From: Laura Gibbons <Laura.Gibbons@arun.gov.uk>
Sent: 31 August 2021 10:56
To: Planning.Responses <Planning.Responses@arun.gov.uk>
Cc: Michael Eastham <Michael.Eastham@arun.gov.uk>
Subject: WA/63/21/PL- Land East of Tye Lane Walberton BN18 0LU

Engineers Comments Regarding Surface Water Drainage/ Land Drainage

P3	DITCH CROSS-SECTIONS ADDED	SRB	SRB	JEC	20.08.21
P2	ACCESS AMENDED & LONGSECTION ADDED	MJR	JEC	GH	11.06.21
Rev	Description	Drn	Chk	App	Date
ARDENT CONSULTING ENGINEERS					
Third Floor The Hallmark Building 52-56 Leadenhall Street London EC3M 5JE					
Tel: 020 7680 4088 Web: www.ardent-ce.co.uk E-mail: enquiries@ardent-ce.co.uk					
worksafe consultant www.smaiftd.com SSIP SUSSEX SUSSEX SUSSEX					
Client					
VISTRY SOUTH EAST					
Project Title					
LAND EAST OF TYE LANE, WALBERTON					
Drawing Title					
TYE LANE PRELIMINARY SITE ACCESS					
A1 Scale	Date	Designed by			
AS SHOWN	05.11.2020	JEC			
Drawn by	Checked by	Approved by			
JEC	JEC	KM			
Drawing Number	183248-001				Rev
					P3

FOR INFORMATION ONLY

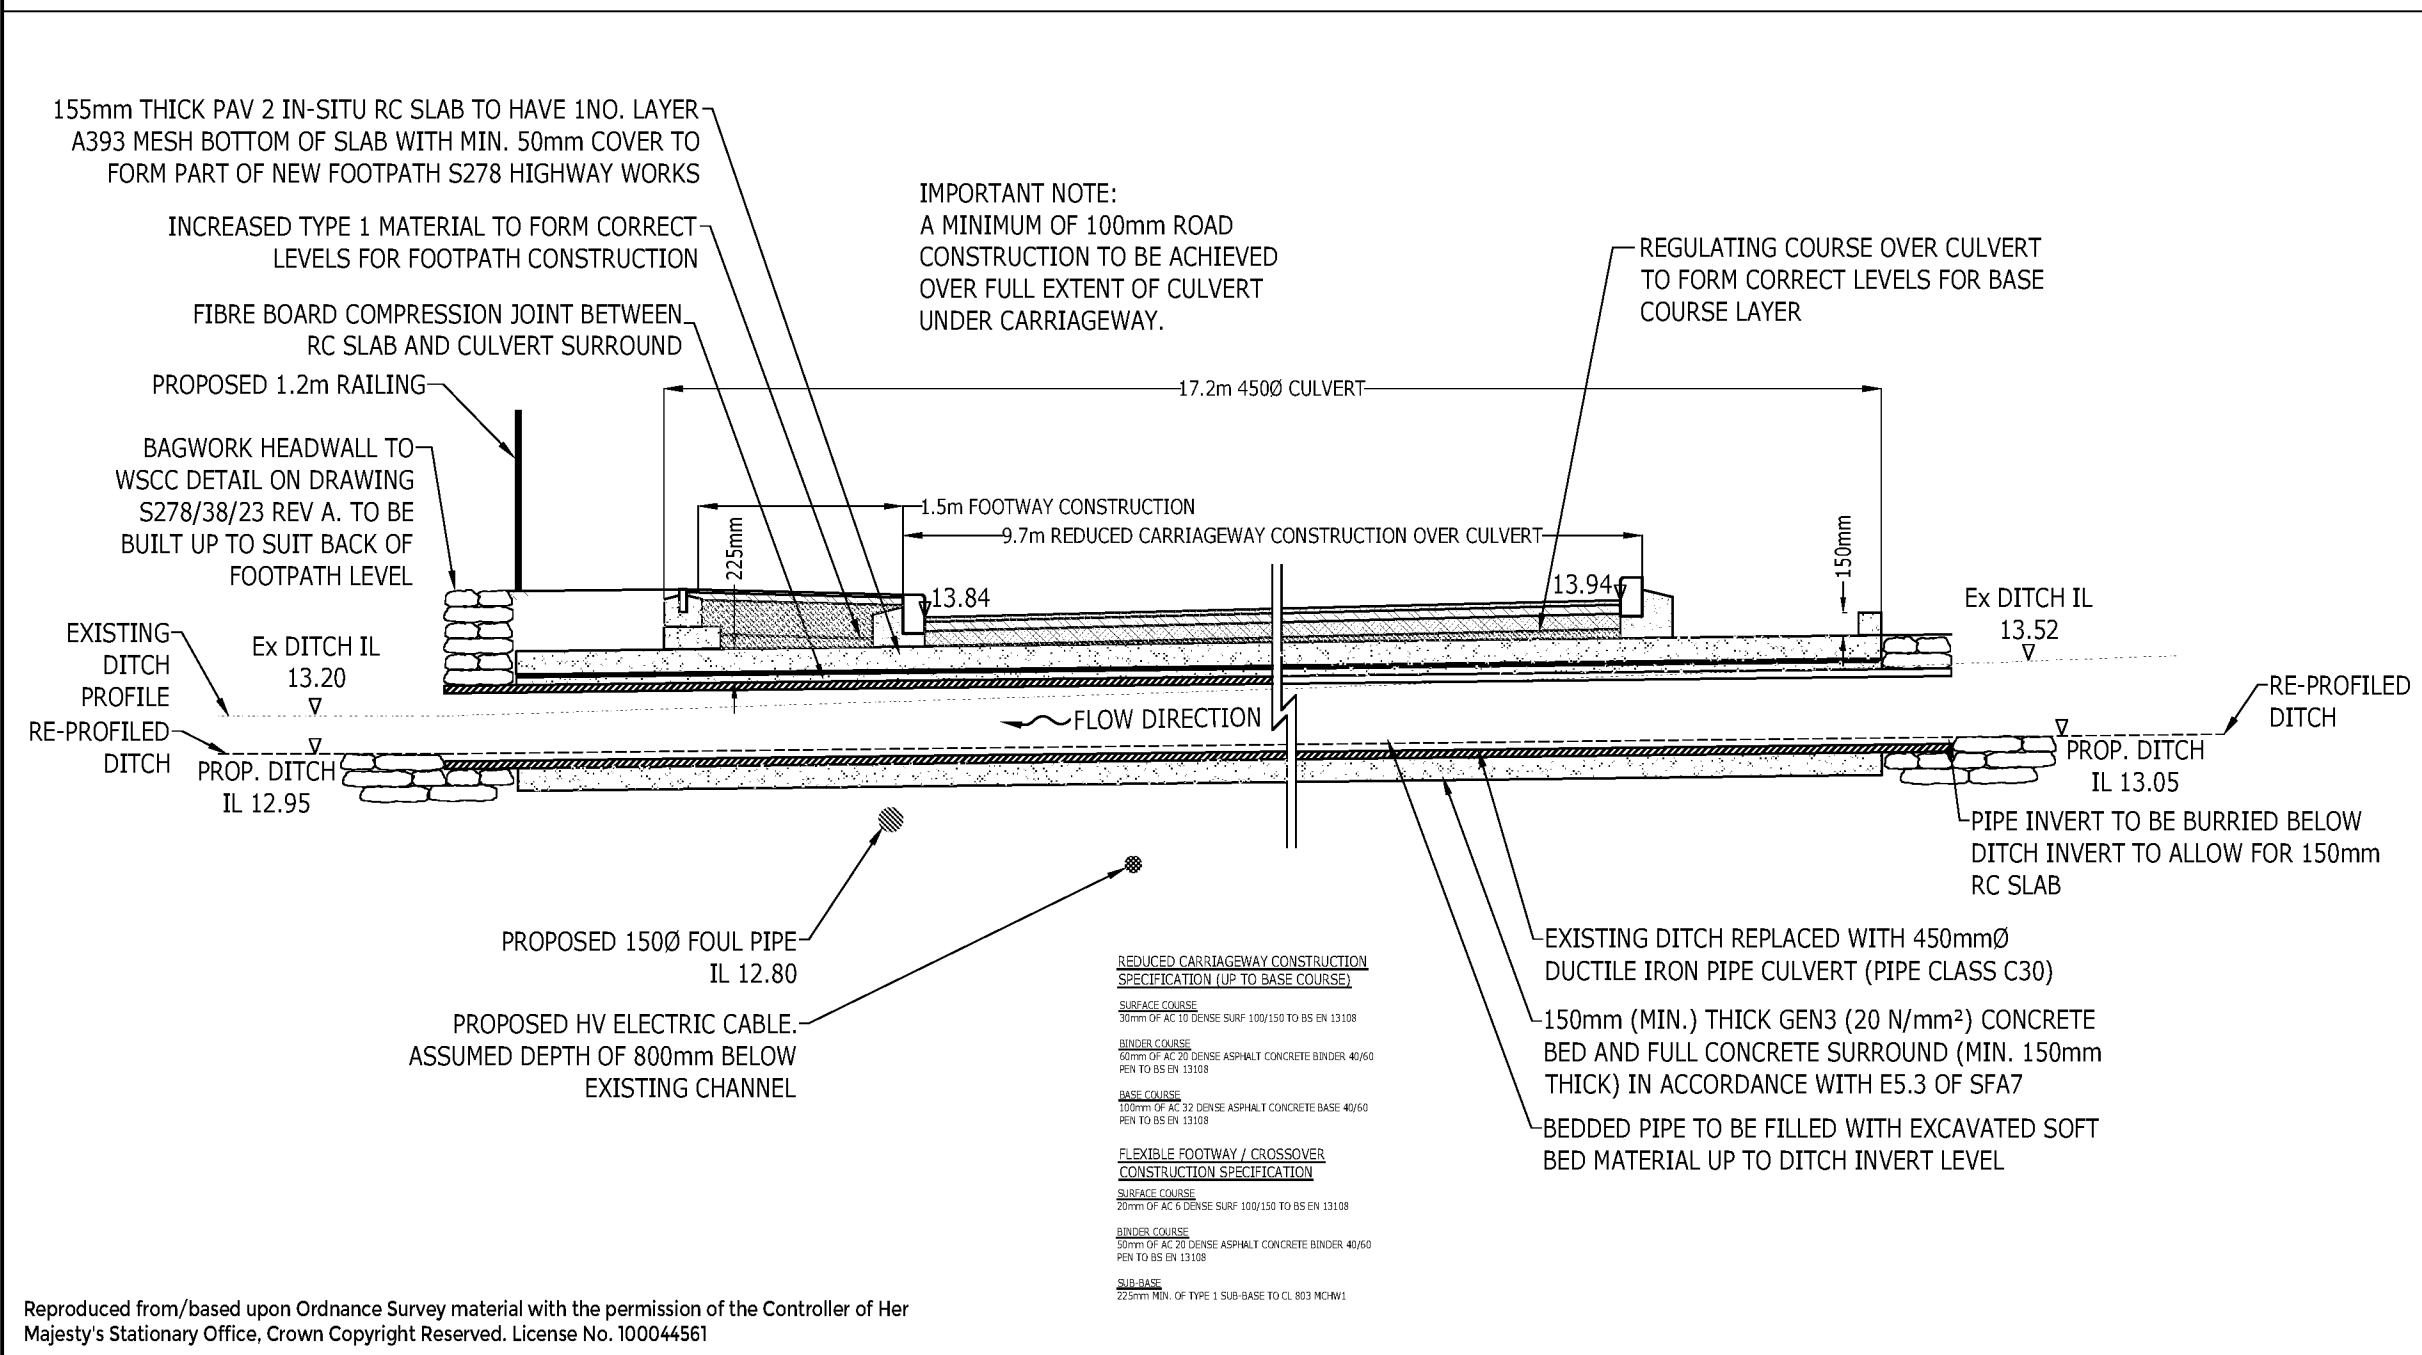
We object to the proposals for the proposed alternative vehicular access off Tye Lane.

Details of proposals for culverting and diverting the watercourse have now been provided, and are attached. We object to the proposals as they currently stand for the following reasons:

1. The new culvert has proposed upstream and downstream invert levels of 13.05 and 12.95 respectively. It is clear that there will be a clash between the proposed culvert and the foul pipe. The foul pipe has an I.L. of 12.8, with a diameter of 150mm, an external diameter of 188mm is typical, therefore this pipe will have a crown level of 12.988. It can be seen this is likely above the invert level of the watercourse culvert at this location, let alone the barrel level of the culvert and base level of the concrete surround. There is clearly a clash.

2. Proposals to provide the longer culvert rely upon deepening the watercourse, it is not clear if this will be possible with the constraints that exist.

3. In order to form a footpath along the east of Tye Lane it is proposed to divert the ditch. The supplied cross sections show:
 - a. The proposed cross sections are narrower than the existing cross sections and will therefore result in a loss of capacity.

- b. The proposed cross sections are proposed to have steep 1:1 banks. These banks are steeper than existing banks, it is unlikely that the proposals will provide a long term stable watercourse. Proposals will likely result in erosion and collapse or a need to engineer banks which could result in a loss of natural habitat.

- c. There is a line of TPO trees along the eastern bank of the watercourse, it is unclear how the new watercourse profile can be provided without damaging these trees.

In summary it has not been evidenced that the new access can be delivered whilst maintaining the free flow of water and capacity within the watercourse.
